13. (HDP-4-Q13) Comment: The information provided does not allow the staff to determine whether the background bedrock monitoring wells are located in appropriate sampling locations.

Figure 28
Groundwater Flow Map: Jefferson City Formation, August 2002

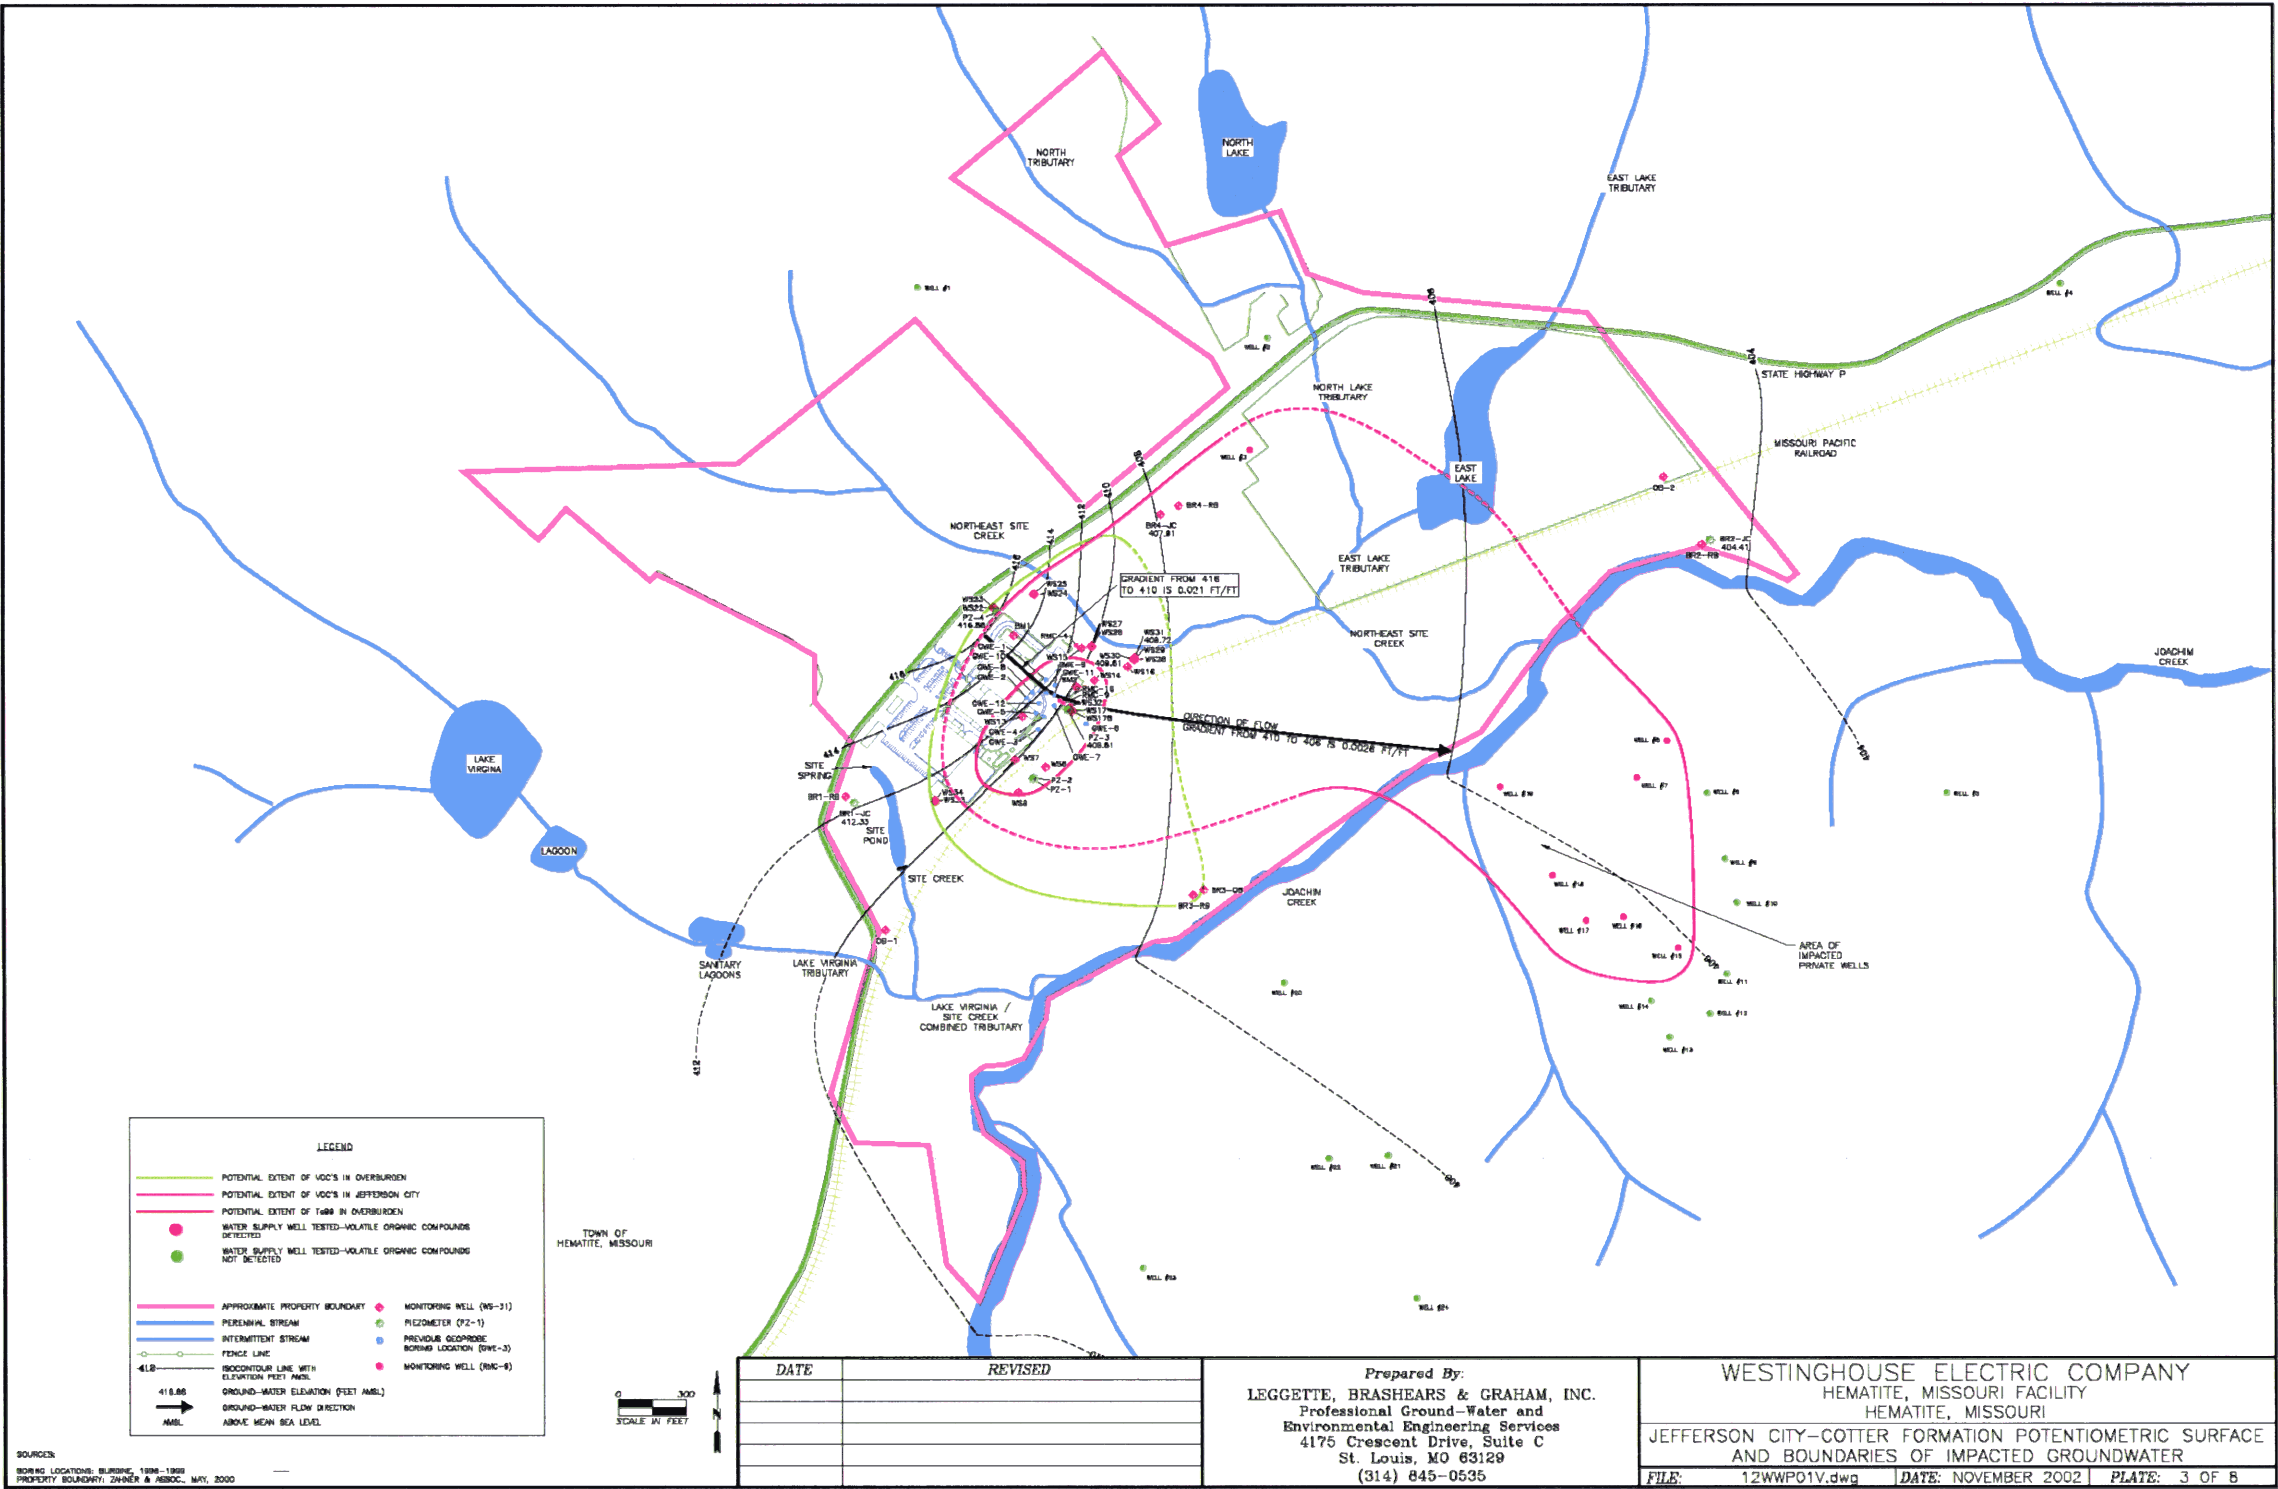
Basis: Figure 3-32 in the HDP indicates that well BR12RB may be down gradient of the site, but the figure lacks sufficient detail to provide a clear understanding of the groundwater flow regime. This ambiguity is significant because bedrock well BR12RB appears to have the highest level of 234U when compared to all other bedrock well data provided in the Radiological Characterization Report.

Path Forward: Provide figures for all bedrock well locations. The figures should include detailed potentiometric elevation maps for each bedrock unit pre and post Festus municipal well shut down.

The inferred direction of groundwater flow for the two bedrock units prior to the Festus municipal wells being shutdown was assessed in the Interim Hydrogeologic Investigation to Support the Engineering Evaluation and Cost Analysis for Response Actions for Off-Site Ground-Water Quality Impacts dated November 15, 2002. The groundwater flow maps for the Jefferson City and Roubidoux bedrock zones for August 2002 are depicted in Figures 28 and 44 of this response, respectively. The inferred direction of groundwater flow shown on these maps is to the east-southeast.
